# 231<sup>st</sup> Meeting of the Machine Protection Panel

## LHC & injectors topics

November 25<sup>th</sup>, 2022, via Zoom

## Hardware transmission of DC-BCT intensity to SMP SPS and LHC (T. Levens)

Figure 1 SPS BCT / SMP architecture schematics.

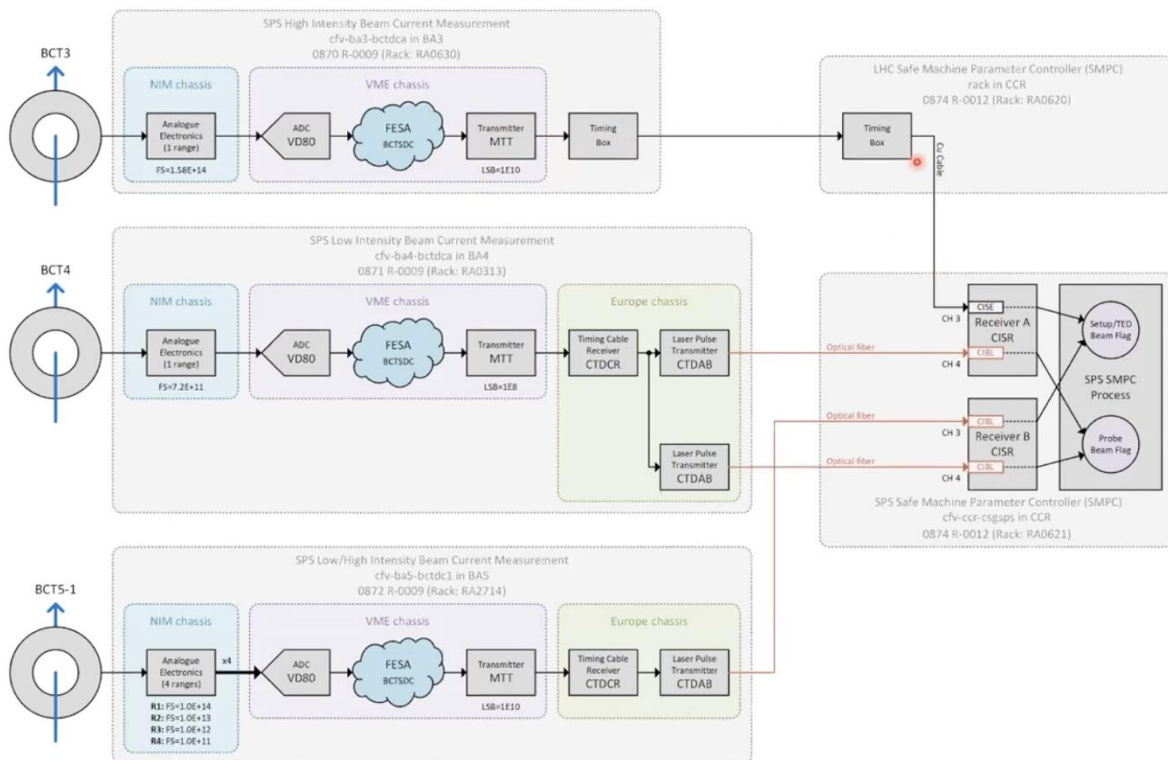
Tom detailed the system architecture, as shown in Figure 1. The same FESA class is deployed for each of the 3 BCTS. BCT4 drives both A and B channels of the SMP without hardware redundancy. BCT3 and BCT4 are very old commercial systems.

The proposal is to keep BCT3 and BCT4 as they are. BCT3 will provide the high intensity channel 3A and BCT4 the low intensity channel 4A. The BCT5 connection will be modified to send SMP directly from VFC-HD. The range 1 will feed the high intensity channel 3B and the range 3 channel will feed the low intensity channel 4B. This requires modifications on the SMP side (see next presentation of this meeting). BCT 5, thus, provides diverse redundancy.

Jan commented on the long history of the issue and thanked the team for improving the system. Jan asked which option should be chosen for the LHC. Tom replied that he proposes to use the direct connection with the VFC. Jan commented that then we should do that from the start. Daniel agreed.

Daniel asked why the same solution is not chosen for the B channel. Tom replied that the B channel is still on the 16-bit acquisition system.

Daniel added that the proposal should be written in a ECR.
